Zooms Carwash & Remodeled Retail Building
at
Gateway Norte
4225 & 4207 S. Power Road
Mesa, Arizona

Pre-submittal Comments

CASE NUMBER: PS16-076 (PLN2016-00694)
ADDRESS: 4207 & 4225 S Power Rd.
LOCATION: NEC Power and Warner
FACILITATOR: Andrew Spurgin, Andrew.Spurgin@mesaaz.gov
CONTACT NUMBER: (480) 644-4691

PROJECT DESCRIPTION: Addition to existing retail and new car wash
Existing General Plan: Mixed Use Activity/Employment
Existing Zoning District: LC-AF-PAD, Limited Commercial,
Applicant: Trudi Licano, Via Companies trudy@gatewaynorte.com

PROPOSED SITE PLAN

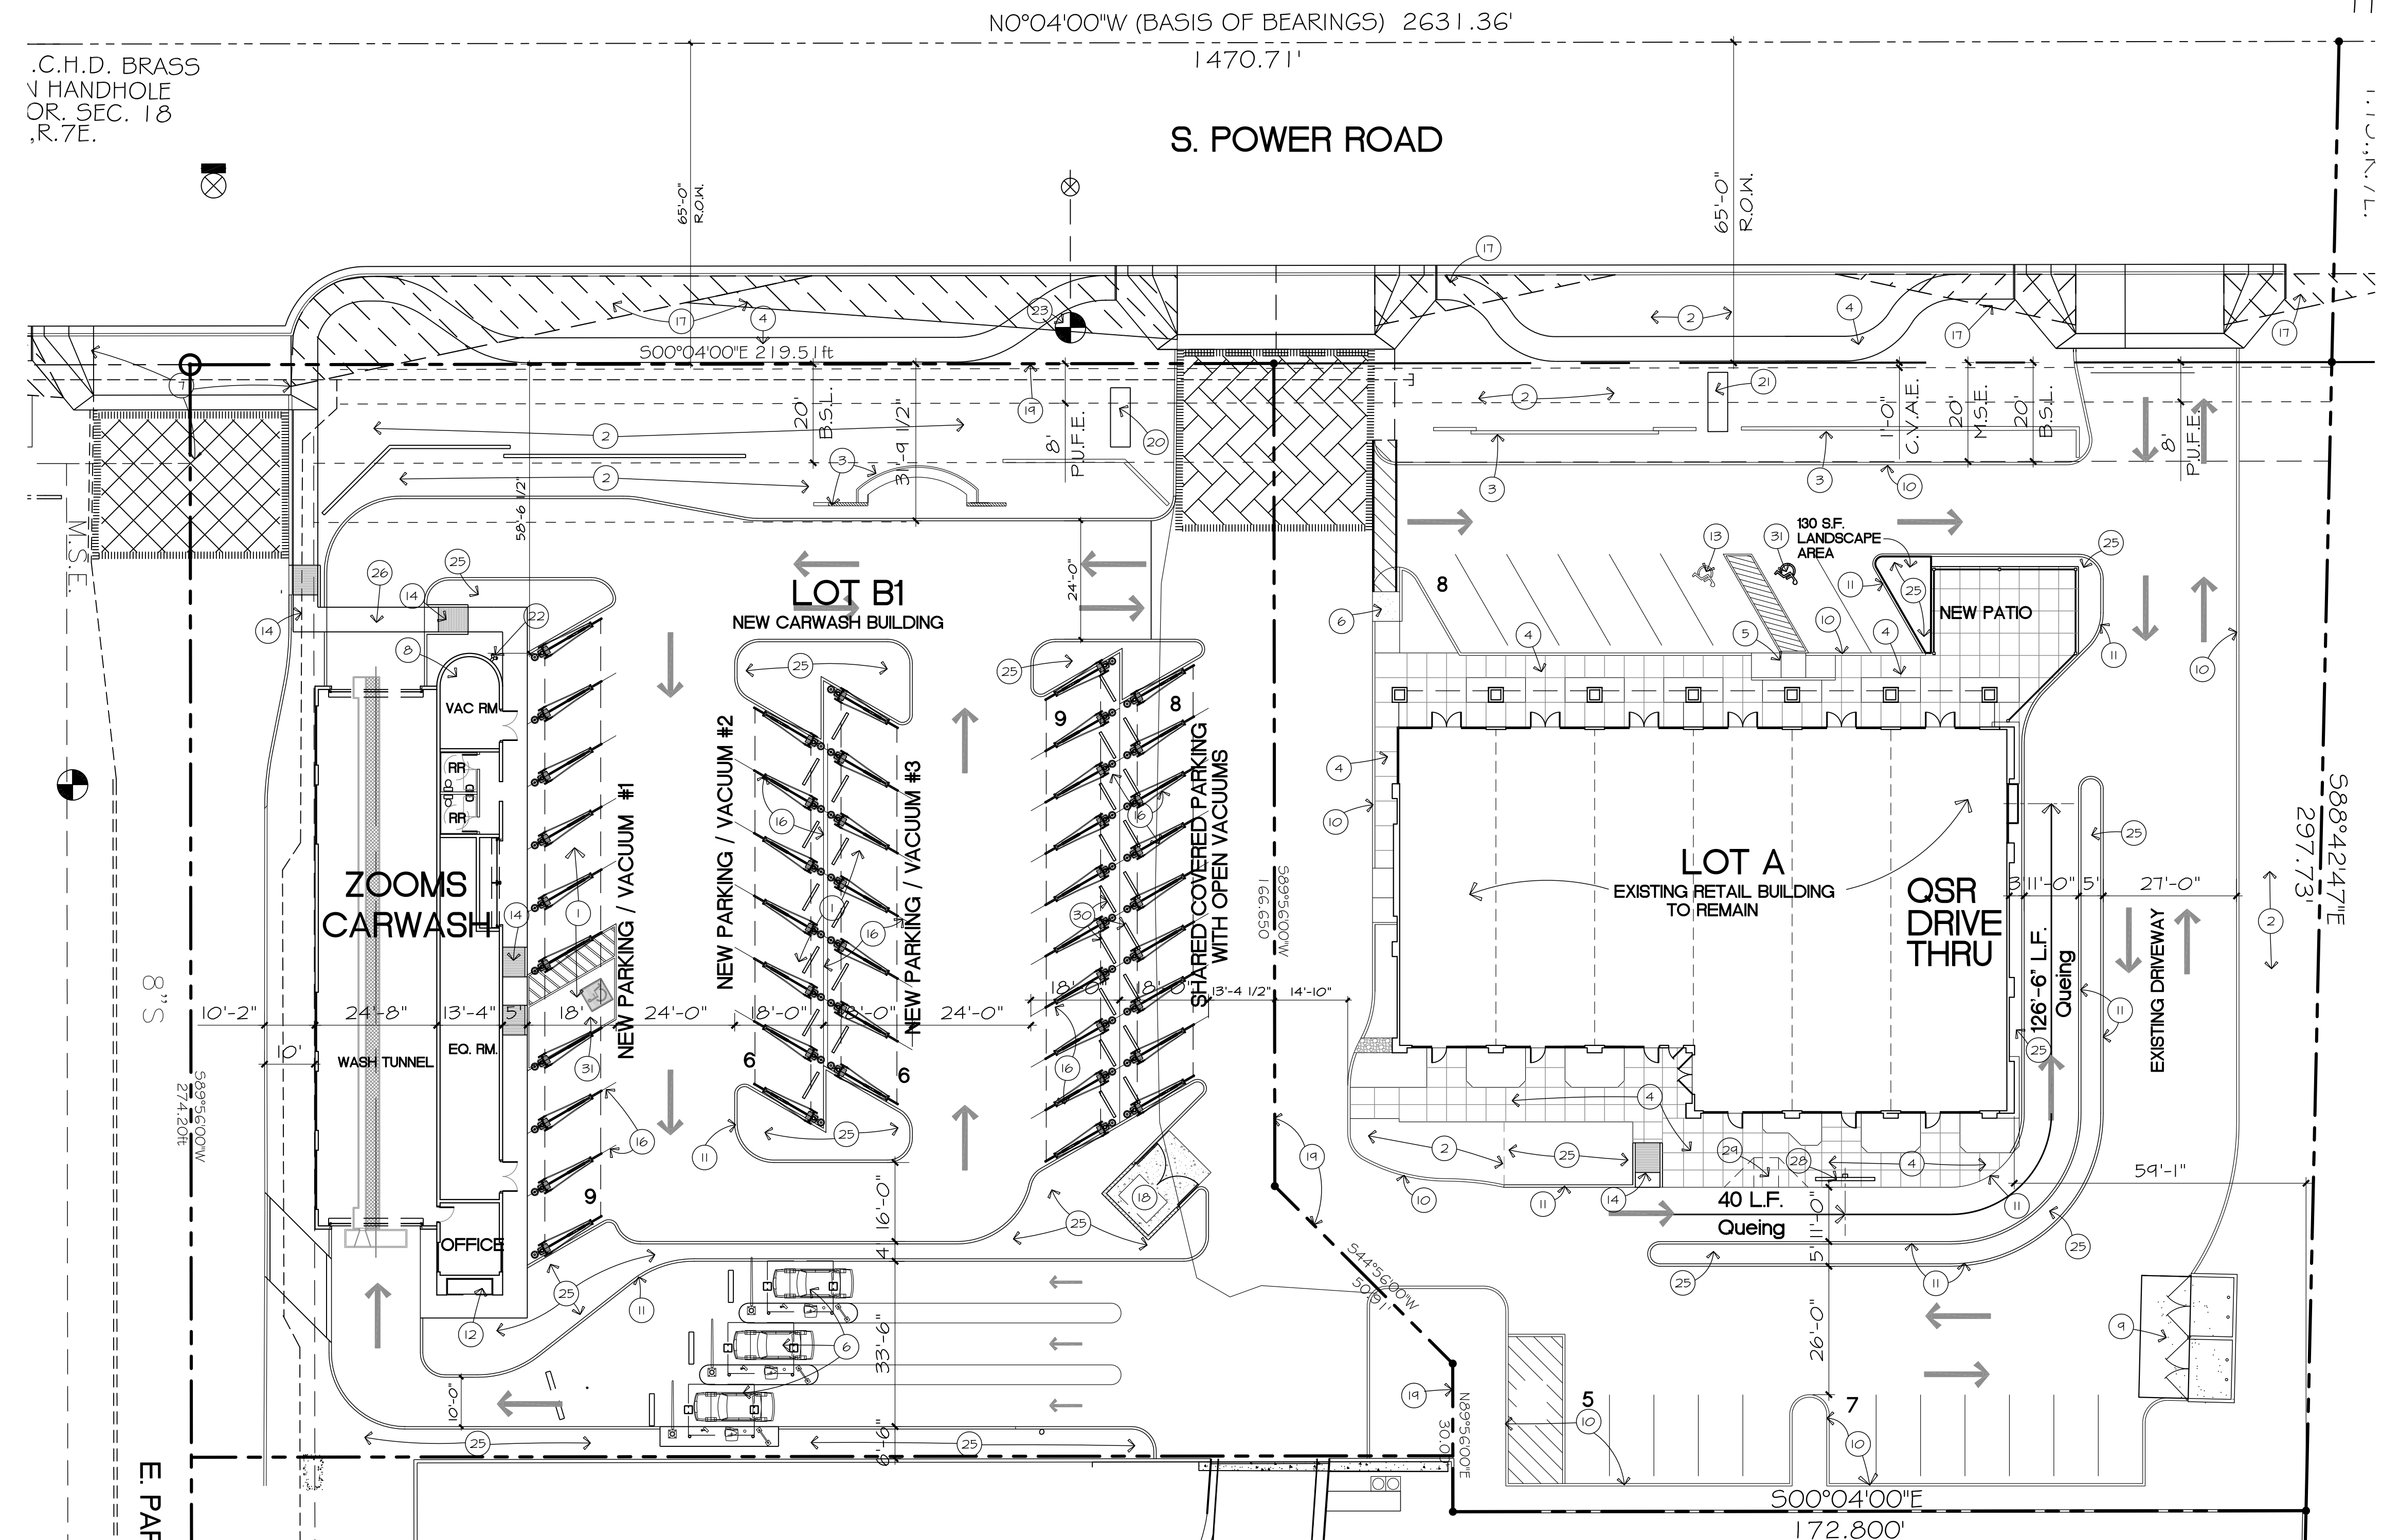
- a. Site plan provided is very crowded on the page
- b. Site plan should clearly show existing improvements versus proposed using clouds to depict changes

- c. Driveways need only be 24' wide for 2-way with parking, 20' width without parking
- d. Setbacks: 15' to Power Road, 20' to Parkway Norte
- e. Pedestrian connections- Pedestrian paths need to be decorative pavement wherever they cross drive aisles.

- f. Parking
 - i. Is the covered parking intended for the office uses?
 - ii. Will the parking/vacuum stations be under a canopy?
 - iii. Need cross access & cross parking agreements

- g. The vacuum enclosure must be fully enclosed (with a roof). Sound readings at street and property lines shall not exceed more than 55 decibels
- h. Circulation is awkward

- i. Is the intent to vacuum before or after washing?
 - ii. Reduce width of one-way driveways
- i. Drive-thru restaurant standards of the zoning ordinance

- i. At least 100' between order speaker and pick up window and at least 40' from entry to the drive-thru lane and the order speaker, required for both drive through lanes

- ii. Menu board screening

preliminary landscape plan

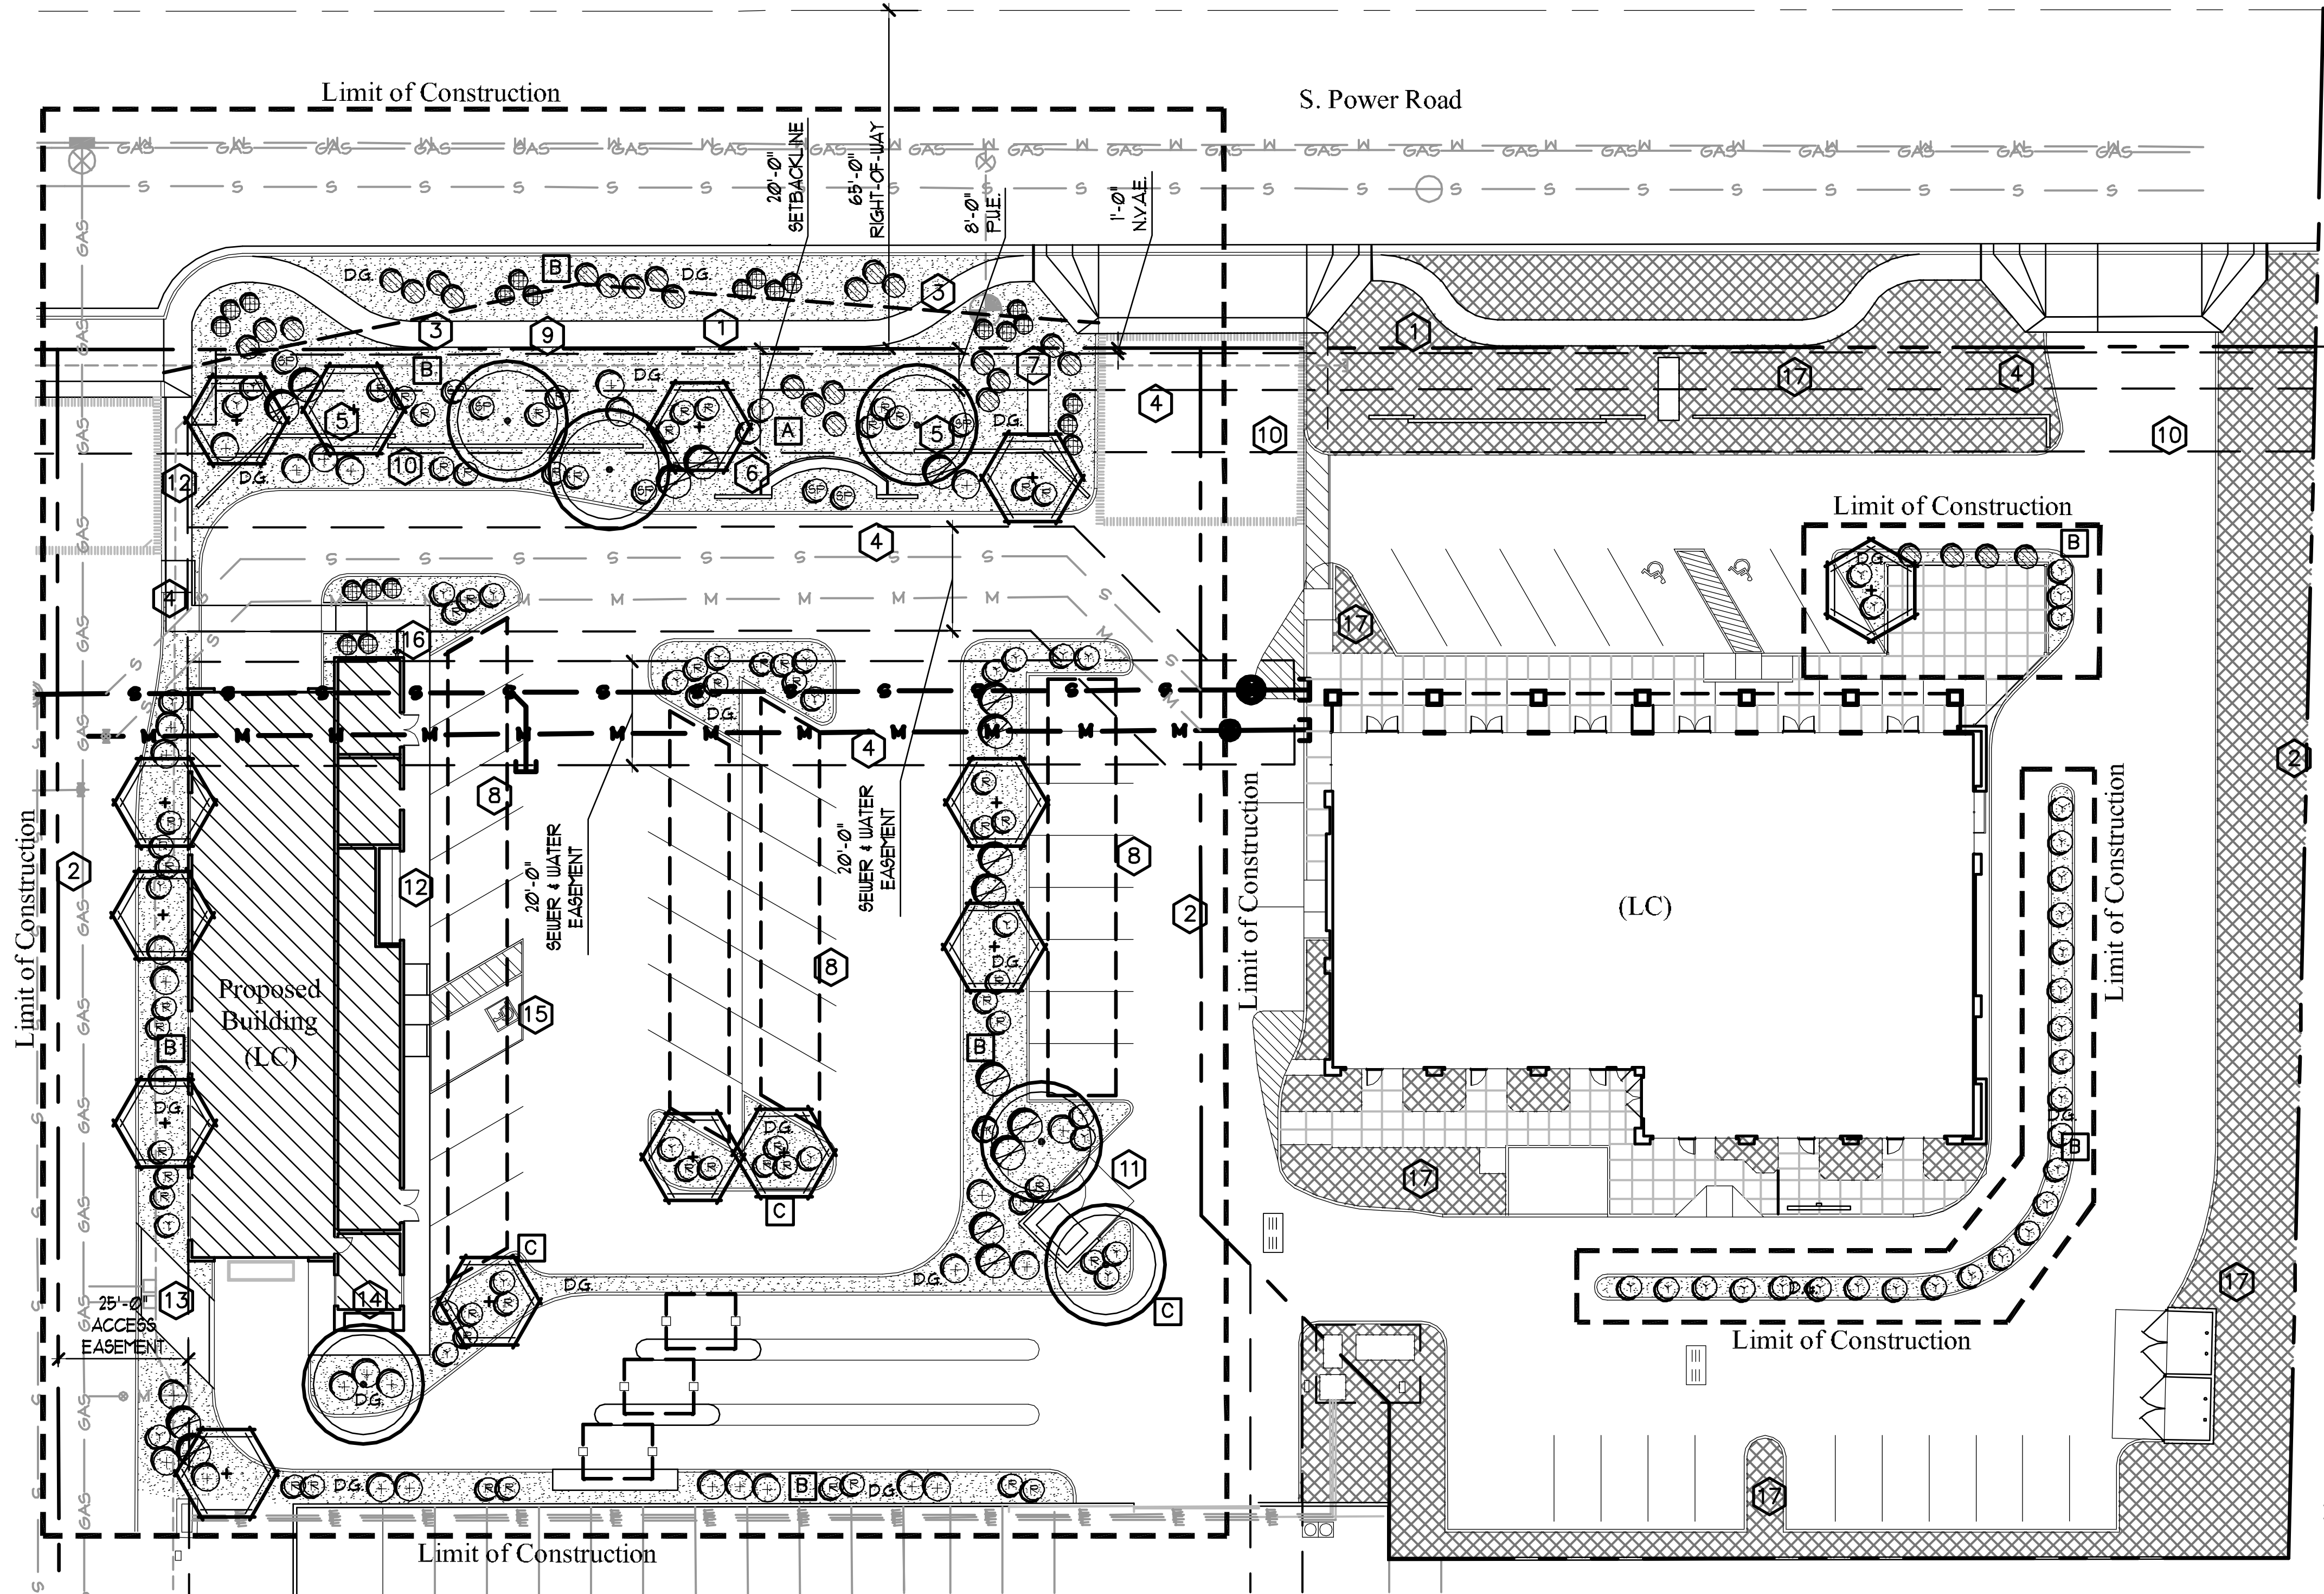
4. Landscape:
- a. Need landscape plan showing materials and yield of each type
 - b. Foundation base landscaping – 15' w/ public entry, 10' w/o entry and 5' along driving aisles with options for hardscaping w/in the foundation base

- c. Drive-thru:
 - i. 5' wide raised landscape median to separate outside portion of drive through lane
 - ii. Min. 2' foundation base adjacent to drive-thru lane

- d. Minimum 10% of car wash site shall be landscaped
 - e. Perimeter landscaping shall be provided to the distance of minimum building setbacks
 - f. Reduce driveway widths as described above: one-way aisle 14'; 2-way w/o parking 20' or 2-way with parking 24'

PRELIM CARWASH ELEVATIONS

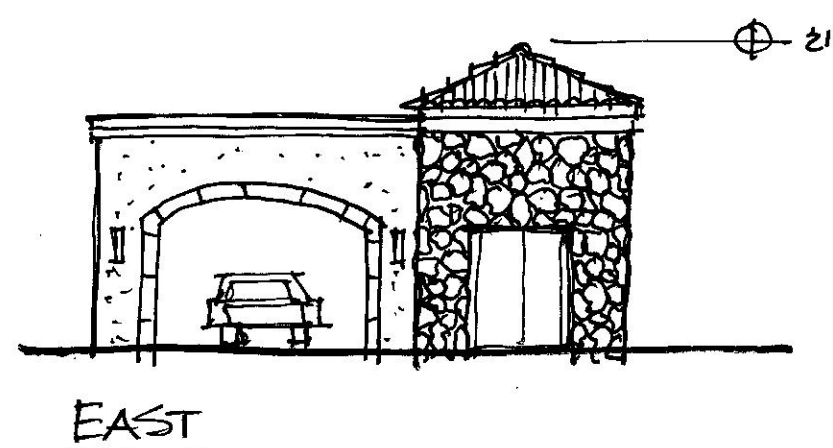
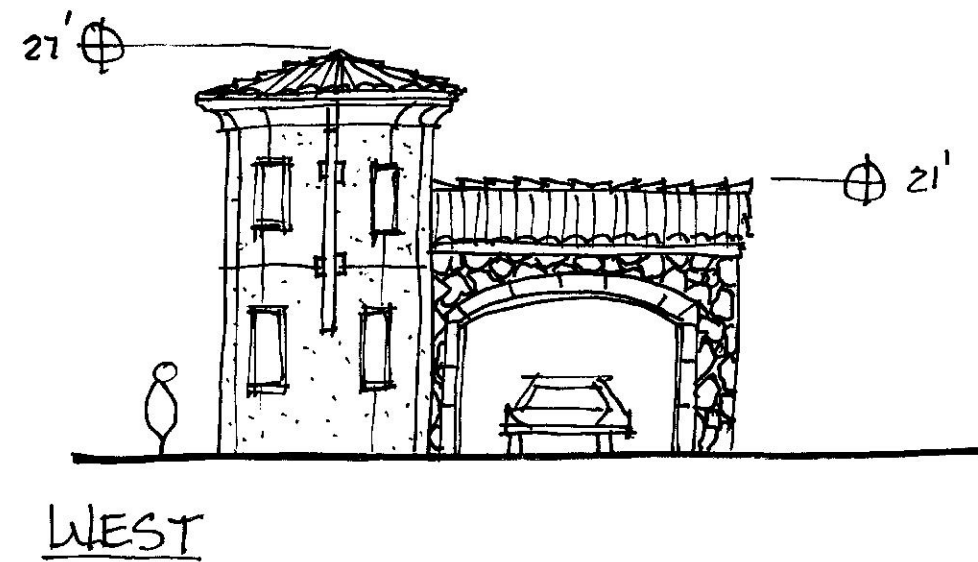
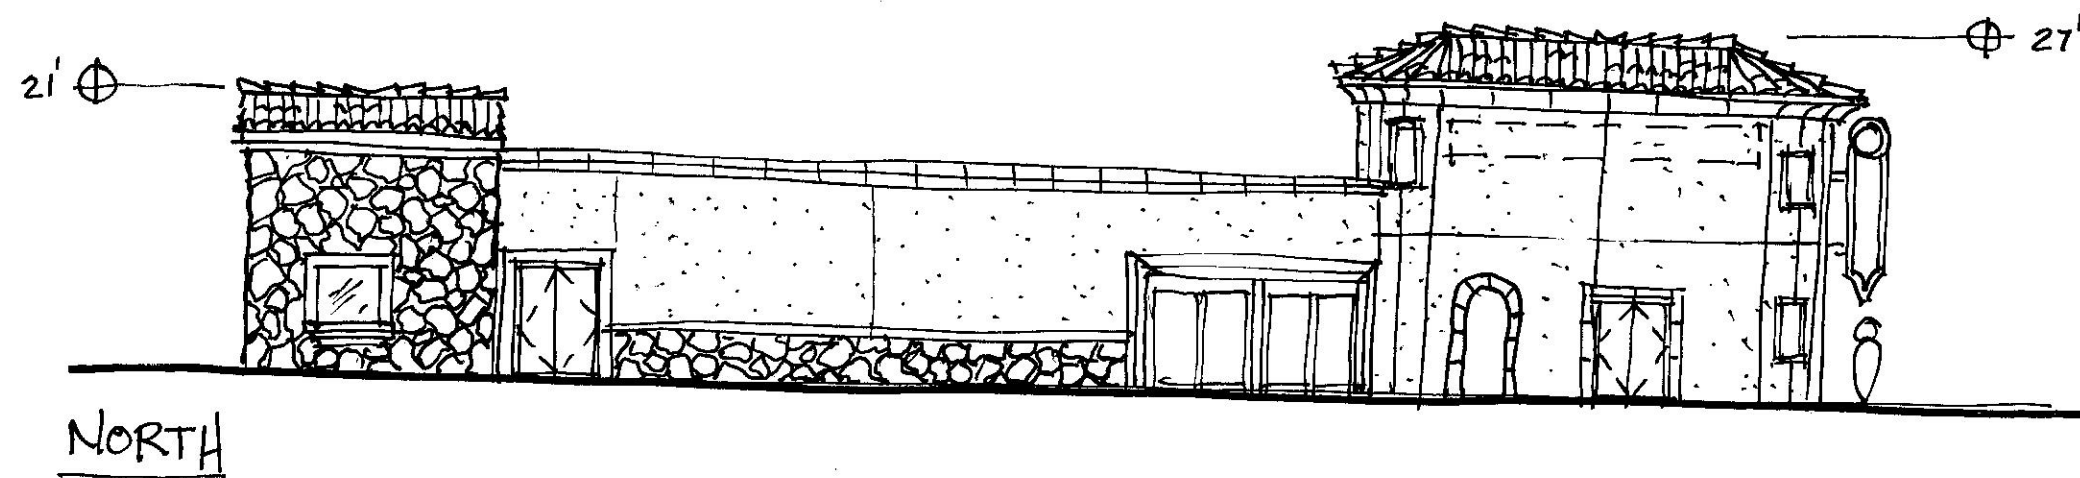
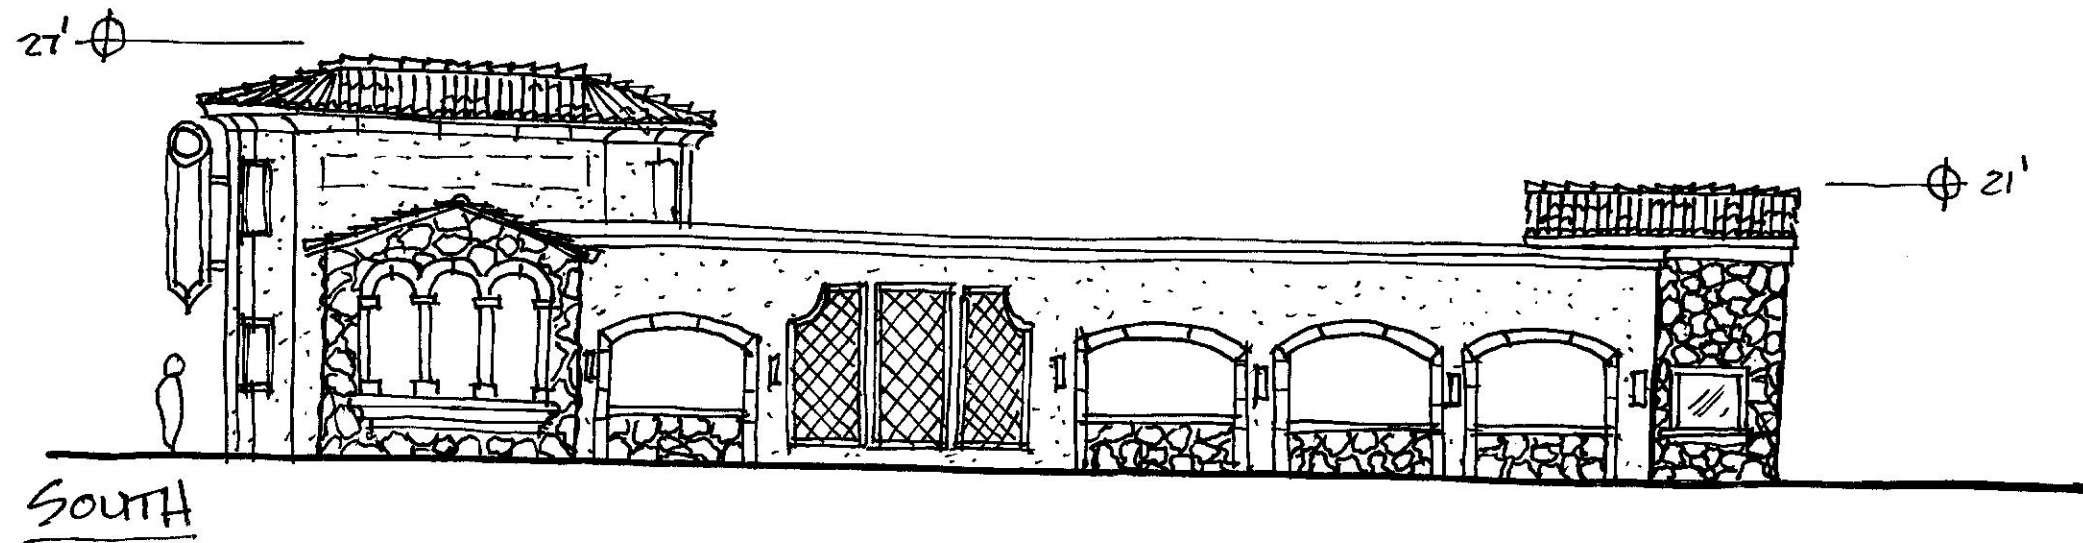
- a. Design Review Board required
- b. Design is to be consistent between buildings

- c. Minimum requirements include variety in wall plane, variety in height and roof forms, façade detailing, projections/recesses
 - d. Integrated canopy for drive-thru

- e. Integrated canopy for the outdoor dining is the preferred design – roofed with columns compatible with primary building
 - f. South elevation of the car wash tunnel will need visual interest due to its presence along Parkway Norte with windows, pop-outs, etc
